1. Type of Change (Major or Minor)

Major

2. Change Description

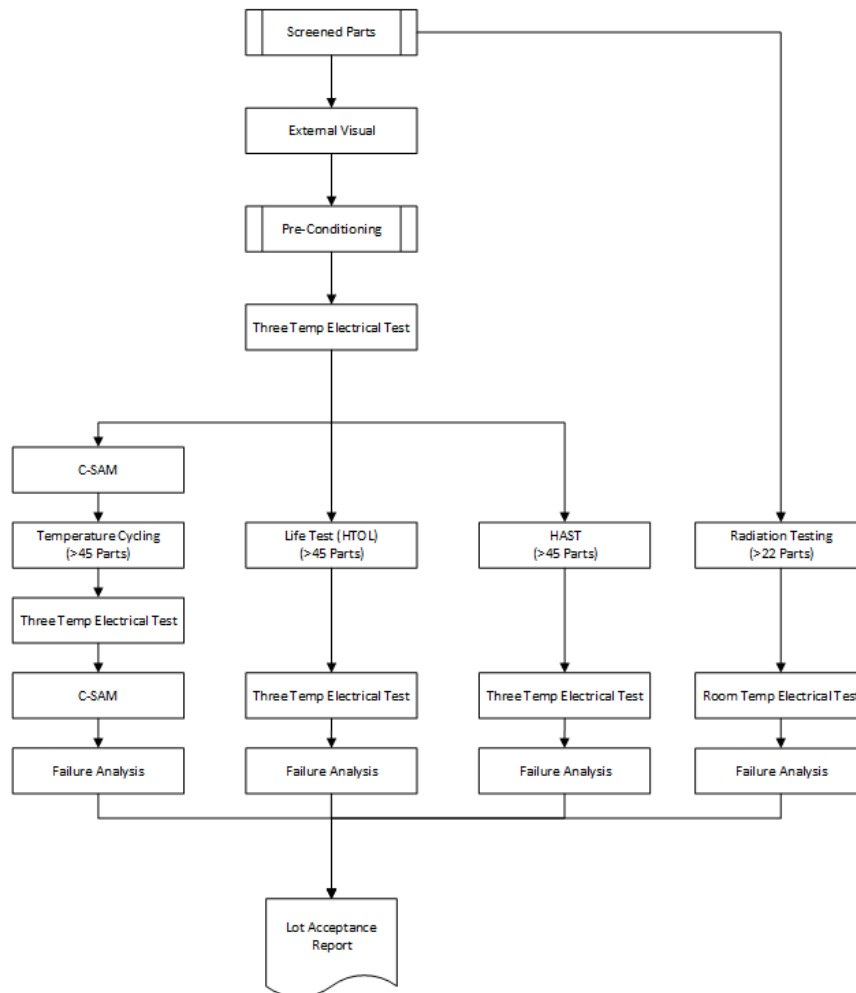
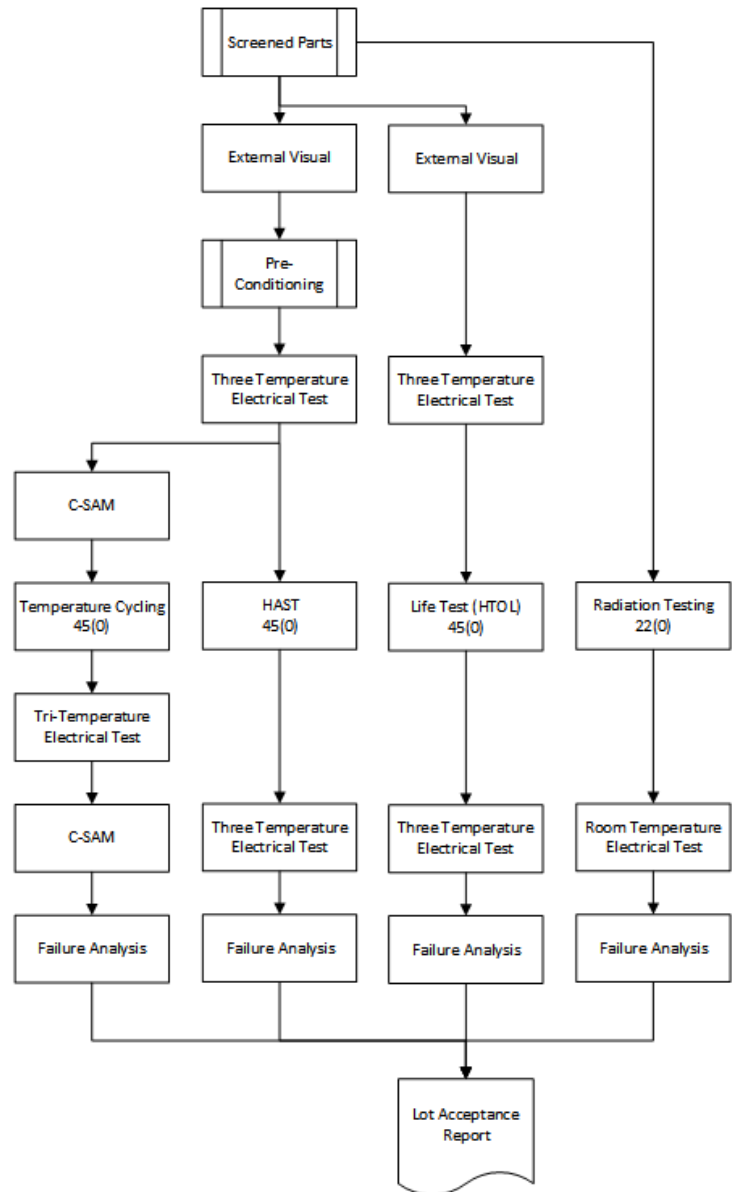
Preconditioning is being removed from Apogee Semiconductor's HTOL lot acceptance flow to better align with industry standards (MIL-PRF-38535 and JESD47). Preconditioning will still be conducted prior to temperature cycling and HAST stress tests.

Simplified lot acceptance flow for the HTOL stress.

Pre-conditioning is not required prior to the 1,000 hour HTOL test according to MIL-PRF-38535 group C requirements nor JESD47 HTOL requirements. Pre-conditioning is primarily a package stress while HTOL is primarily a silicon stress.
